Origination Form
Proposed Revisions to a Standard Plans Index

Originator:	Pinkham, Andrew	Index Number:	430-030
Date:	6/3/2025	Sheet Number(s):	2
E-mail:	andrew.pinkham@dot.state.fl.us	Index Title:	Straight Concrete Endwalls Single and Multiple Pipe

STRAIGHT CONCRETE ENDWALLS
SINGLE AND MULTIPLE PIPE

INDEX
430-030

Sheet 2: Added SECTION A-A to show Option I or II.

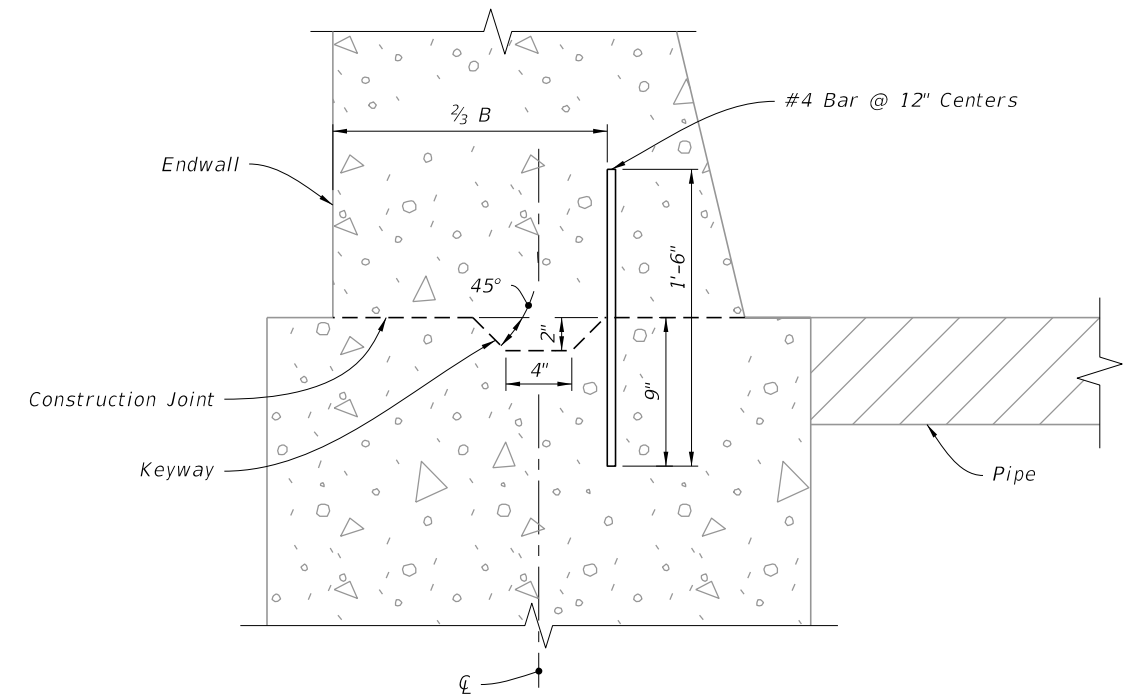
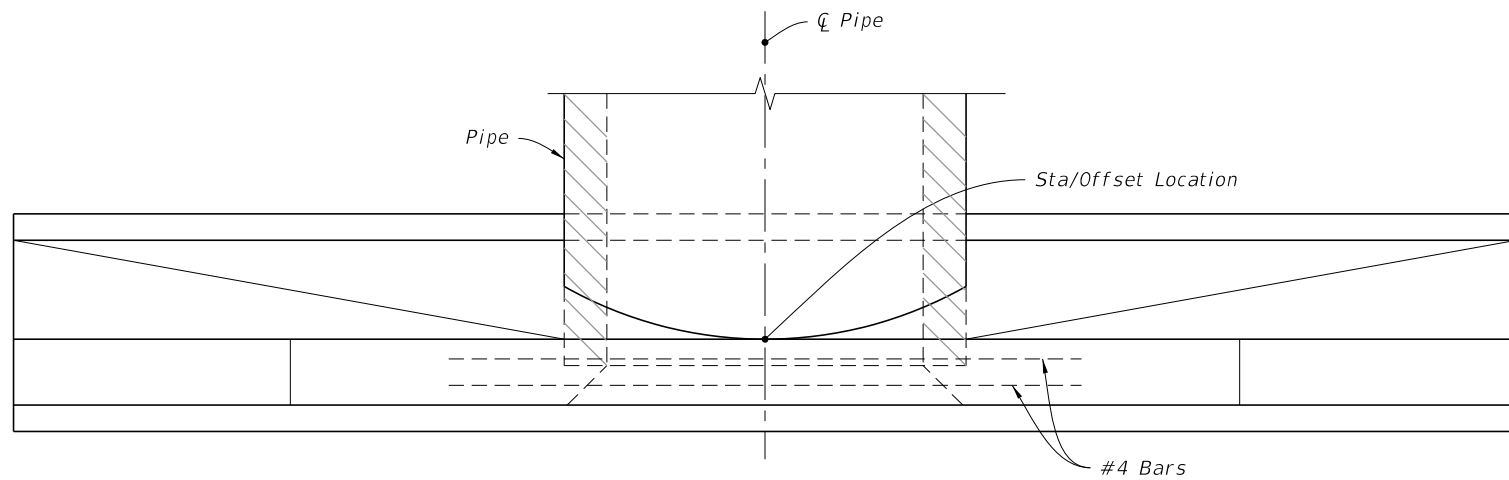
Addition of alternate to hole forming details and minimum beam height above the opening. Issues with delivered product and at request of Industry. Request came through the Precast Concrete Structures Association to Andrew Pinkham at SMO, through Drainage Design and was signed as an Approved Shop Drawing by State Drainage Engineer.

SECTION A-A

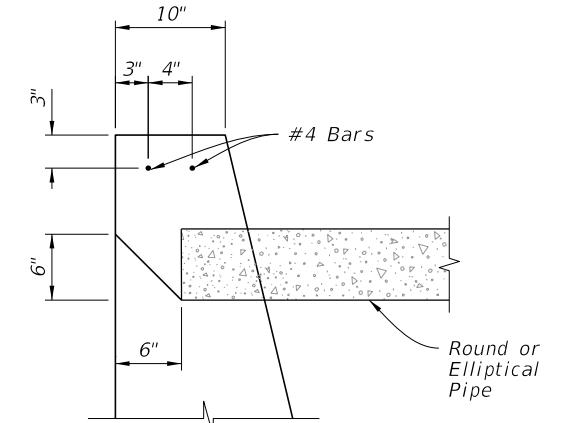
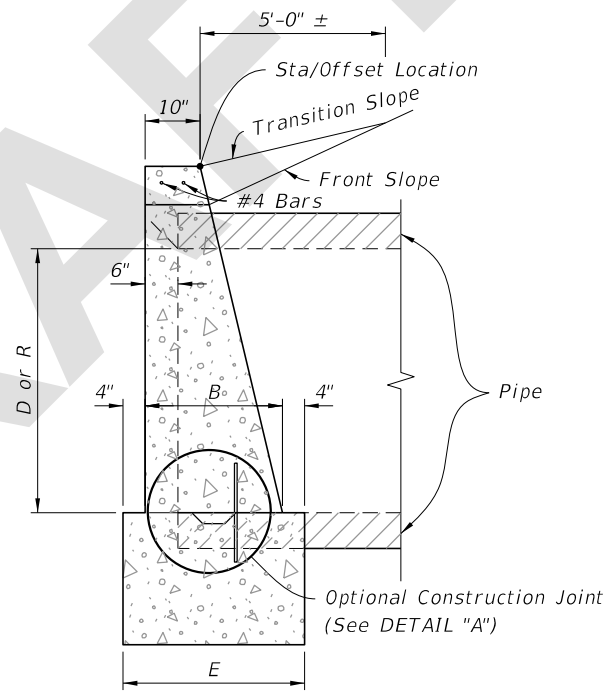
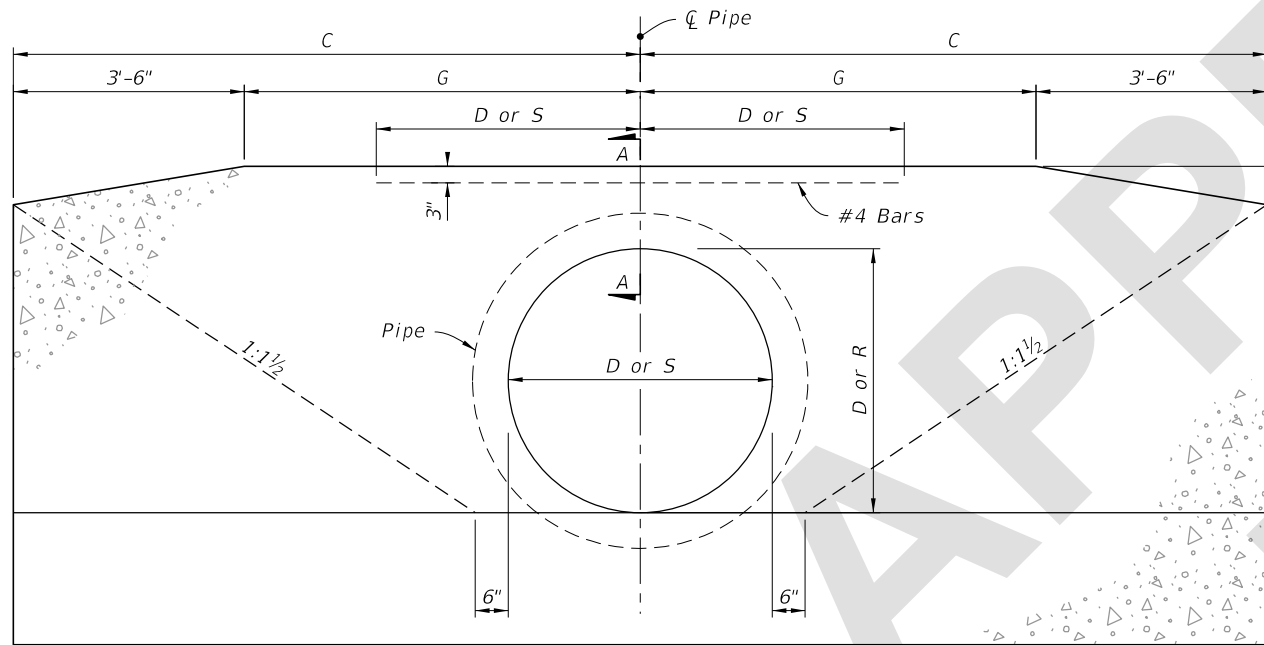
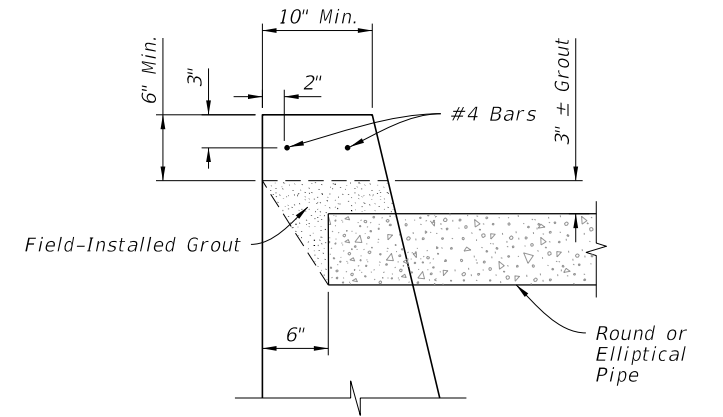
ADDED:
Section A-A to show
Option I or II

NOTE: Keyway and Dowels are required for optional construction joint.
